FEI CPCN APPLICATION FOR OKANAGAN CAPACITY UPGRADE PROJECT	EXHIBIT A-3
---	--------------------

Re: FortisBC Energy Inc. – Application for a Certificate of Public Convenience and Necessity for the Okanagan Capacity Upgrade Project – Project Number 1599152 – Information Request No. 1

INFORMATION REQUEST NO. 1 TO FORTISBC ENERGY INC.

Figure 4-1: ITS Capacity with Mitigation Measures

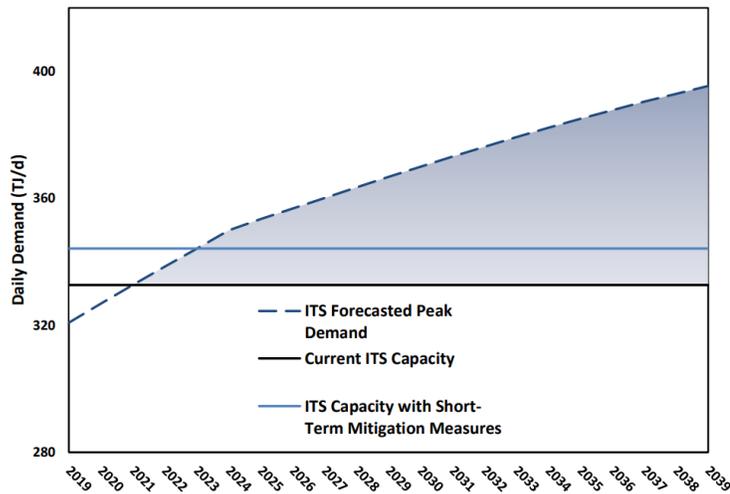
10.1 For each of the four short term mitigation measures FEI is planning to undertake, please explain the following:

- Whether there are any reliability concerns with respect to the measure’s ability to provide dependable capacity during a peak demand event (assuming overall system capacity was sufficient to meet demand);
- The extent to which potential exists for increased capacity by further expansion of the measure at the location(s) described and/or elsewhere on the ITS, and any implications of expanding the measure;
- The potential longevity of the measure as a reliable capacity solution (assuming overall system capacity was sufficient to meet demand).

10.2 Please provide a breakdown of the estimated capacity increases shown in Figure 4-1 by measure.

10.3 Please further explain how FEI intends to “identify and manage existing customer loads under peak conditions.”
